File No.: 2026-035

Re: **Request for Access to Records under the Freedom of Information and Protection of Privacy Act (the "Act")**

From: ["Lam, Matthew" <matthew.lam@vancouver.ca>](mailto:matthew.lam@vancouver.ca)
To: ["Cheung, Rick" <rick.cheung@vancouver.ca>](mailto:rick.cheung@vancouver.ca)
CC: ["Lee, Tracy" <Tracy.Lee@vancouver.ca>](mailto:Tracy.Lee@vancouver.ca)
Date: 1/22/2025 3:37:00 PM
Subject: Telus Central Office (CO) Buildings - Currently Proposed 4 Sites

From: Jack Hui, M.Eng., P.Eng., CP
Project Name: Fairfax – Telus CO
Project Address: 6486 Chester St, Vancouver, BC
BP Number: N/A
Subject: Fire Department Access Arrangement Memo

Figure 2: Proposed Fire Department Access Arrangement

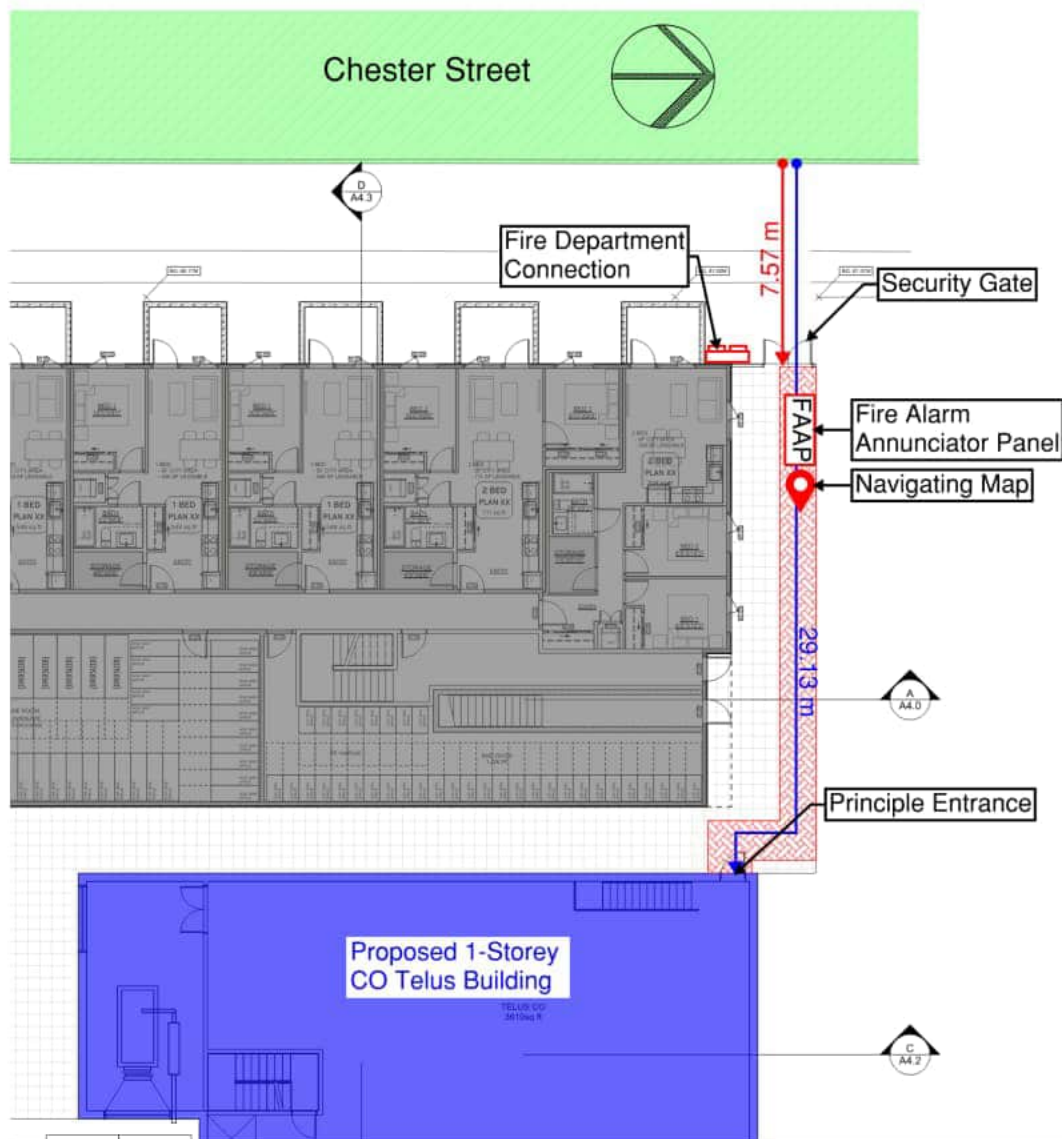
- From the fire truck access route on Chester Street, the firefighter will travel ~7.6m (within 15m) to the fire department connection and the security gate that has a signage indicating the Telus CO building address and entrance is through the gate.

- By providing close proximity of the proposed security gate, Building address signage, and fire department connection from the access route, the firefighters are able to connect the fire truck hose to the fire department connection. Therefore, this arrangement facilitates fire suppression operation.

- After entering the security gate, a heated and conditioned closet housing the Fire Alarm Annunciator Panel (FAAP) is proposed in close proximity from the gate. The gate will provide security to prevent any tampering to the FAAP.

- Having the FAAP situated outside within the security gate will reduce the affect of fire on emergency responders during staging and on the notification device (FAAP).

- A navigating map providing graphical guidance to the Telus CO building entrance will be provided for firefighter.
 - The map facilitates emergency response and notification through providing information for firefighters to navigate to the building.

- To enforce visual guidance to the building entrance, a contrasting path will be provided along the firefighter's path from the gate to the building entrance as shown in the Figure below.

- The marked path to the building entrance reduces the chance of delayed emergency response.
